**Z-31
(2012)
Revised Site
Plan**

PETITION NO: Z-31

APPLICANT: Brooks Chadwick Capital, LLC

Z-31 BROOKS CHADWICK CAPITAL, LLC

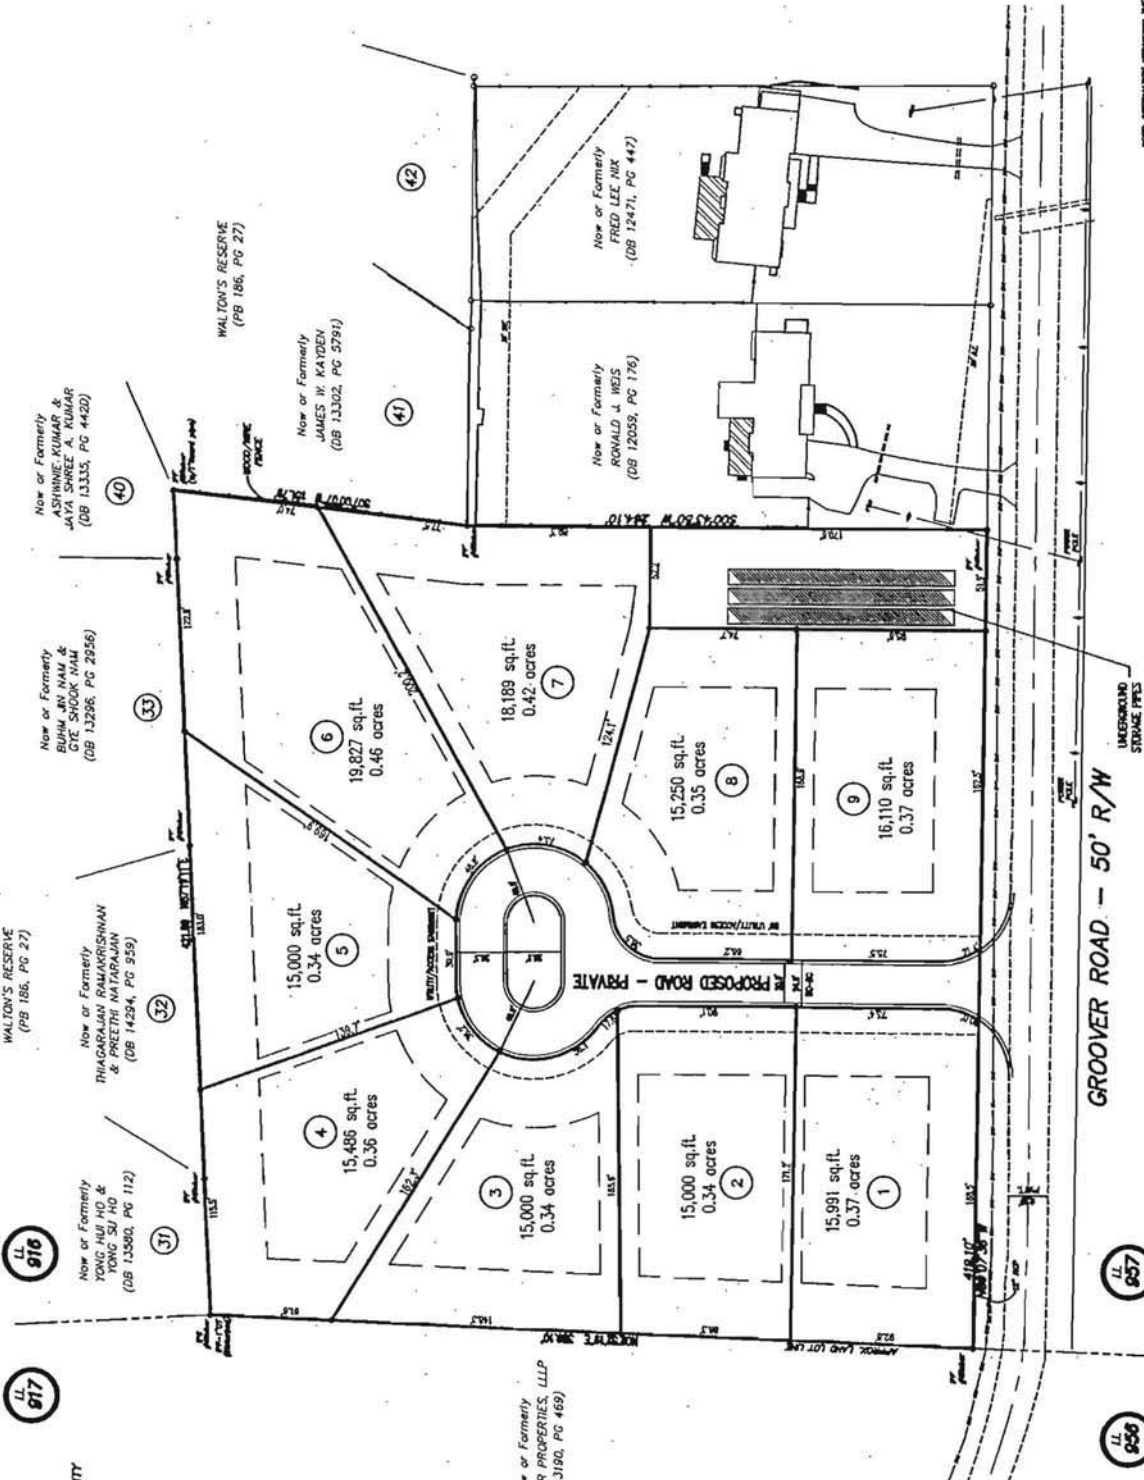
- No Stormwater controls shown _____
- Copy of survey is not current – Additional comments may be forthcoming when current site conditions are exposed.
- No site improvements showing on exhibit.

1. This parcel is a relatively gently sloped, mostly wooded site. The entire parcel drains to the southeast corner where it discharges to a shallow swale and private driveway culvert on the adjacent residential parcel to the east. The site receives approximately 4.3 acres of offsite runoff from the Groover Properties parcel to the west and the existing Walton’s Reserve Subdivision to the north.

2. Due to the site’s natural drainage pattern, existing downstream conditions and the close proximity of an existing low-lying downstream residential structure an underground stormwater management facility is proposed. This will allow the facility to control runoff from the entire site while not creating a dam breach hazard for the existing downstream residence. In order to utilize an underground facility the development will need to be private with all interior stormwater piping as well as the detention facility to be maintained by the homeowners association. A maintenance agreement must be included in the subdivision covcnants and adequate reserves created to maintain the system in perpetuity.

3. A downstream drainage easement will be required to tie the site discharge directly to the downstream road culvert under Groover Road.

Recommend curb, gutter, and sidewalk along Groover Road frontage.

Recommend applicant verify that minimum intersection sight distance is available along Groover Road. If it is not, the applicant will have to implement remedial measures, subject to approval by the Department of Transportation to achieve the minimum requirement of 280 feet.

- Revised site plan submitted to the Zoning Division on July 2, 2012, with the District Commissioner approving minor modifications;
- Water and Sewer comments and recommendations;
- Stormwater Management Division comments and recommendations; and
- DOT comments and recommendations.
